Evaporation Pond
Repairs
(1 of 2)

RE: RESPONSE TO DISAPPROVAL LETTER REPORT
EVAPORATION POND 7 DIKE BREACH AND SUMMARY REPORT EVAPORATION POND
REPAIRS
WESTERN REFINING SOUTHWEST, INC. GALLUP REFINERY
EPA ID # NMD000333211
HWB-WRG-15-006

At Western Refining Southwest's (Western's) request, this letter provides Axis Group Inc.'s (Axis') responses to New Mexico Environment Department's (NMED's) August 22, 2016 comments regarding the *Summary Report-Evaporation Pond Repairs* dated December 17, 2015. Responses to the NMED's comments have been incorporated into the Revised Summary Report, Evaporation Pond Repairs as appropriate.

Giant Refining Company Ciniza Refinery Evaporation Ponds Boring Plan

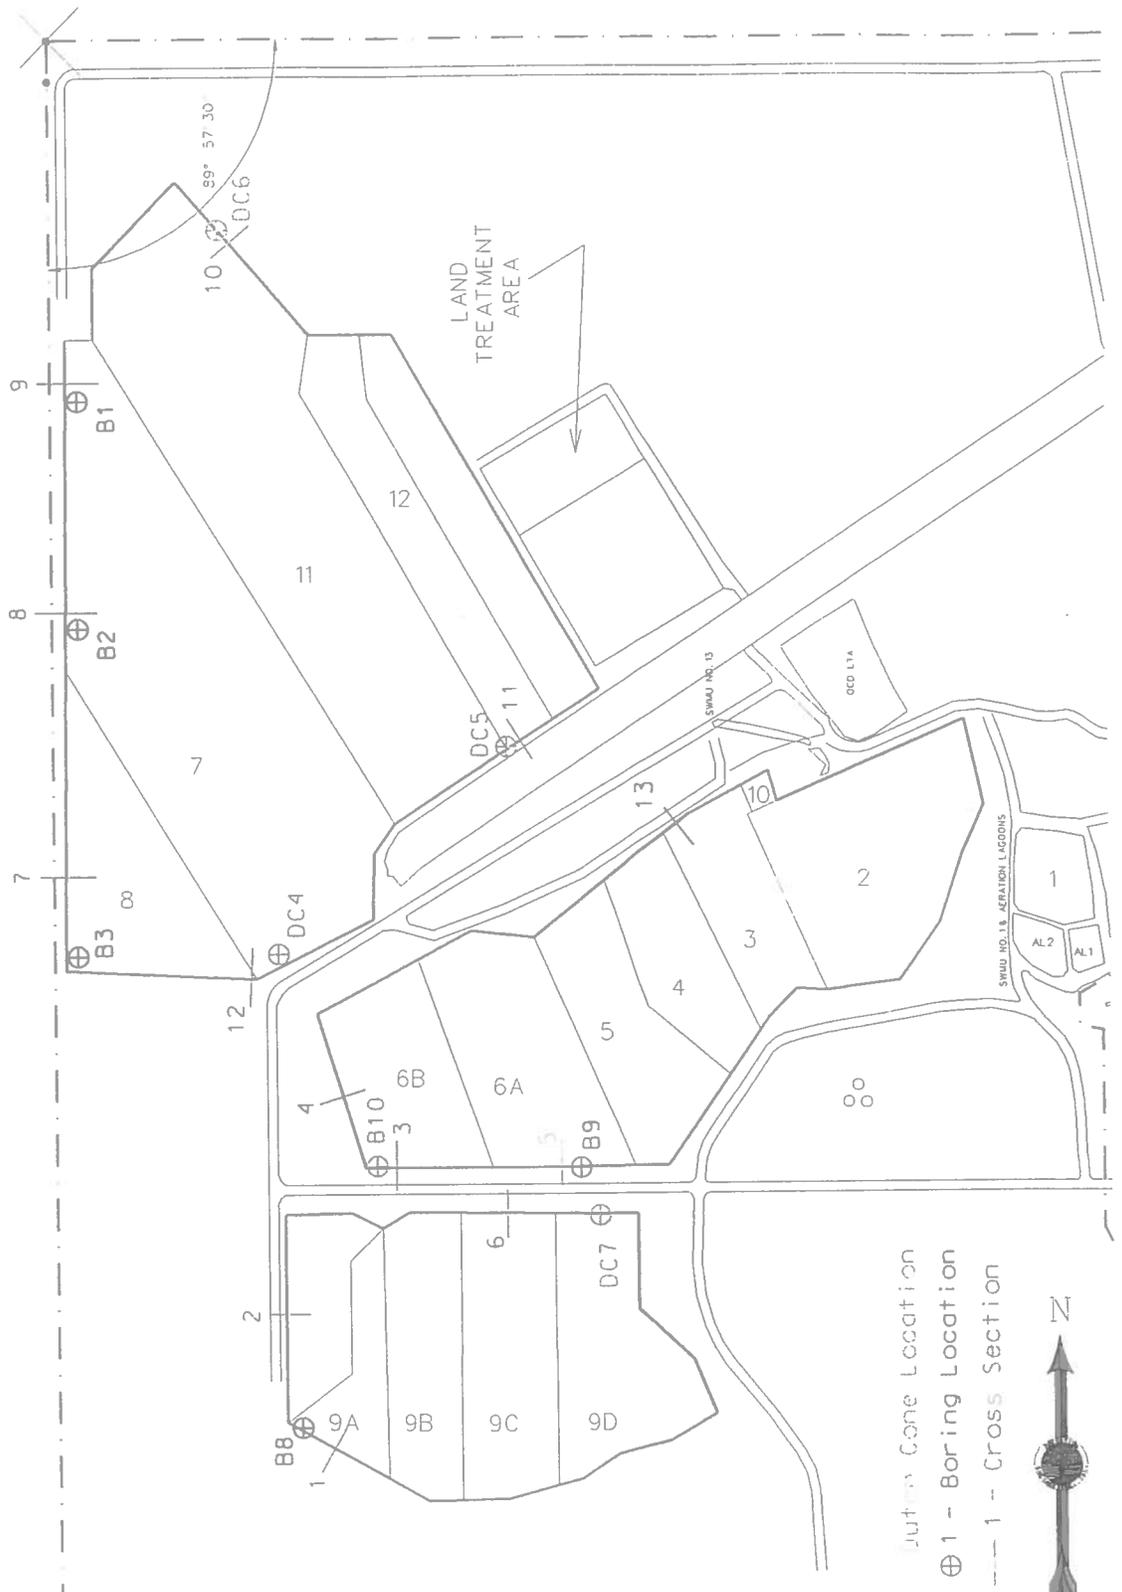
- D:** *For example Boring 8 (Southwest Corner of Pond 9A) indicates that the depth to water is 18 feet with a note "water bearing at 18', water rises to 6'2" after 24-hours and stabilizes." From 10 feet below the berm surface and down, the soil descriptions are "slightly sandy" at 10 feet, "very sandy" at 15 feet, and "sandy" at 20 feet. This is evidence that the evaporation pond berms allow water to seep through in spite of the calculated 1.9×10^{-7} cm/sec permeability. In the revised Report, discuss the permeability of the berms the sand layers, and whether or not the water observed in the borings presents a risk for berm failure. See also Comment 4.*

Response to Comment 1D:

Western does not agree with the interpretation of the boring log stated in the comment above. The log from the December 2000 program for Boring 8 at southwest corner of Pond 9 indicates "Clay" as the major descriptor with minor descriptors of various portions of sand (e.g. very sandy or slightly sandy).

The 1.9×10^{-7} cm/sec permeability test result referred to in NMED's comment is from a borrow sample taken during the October 2015 program and not from the Pond 9 soil obtained in the December 2000 program. The soil sample taken from the 2015 borrow pit was tested at a geotechnical laboratory for permeability using a flex-wall permeameter method described under ASTM 5084. Appendix B contains the geotechnical data and laboratory test results for the berm improvement activities.
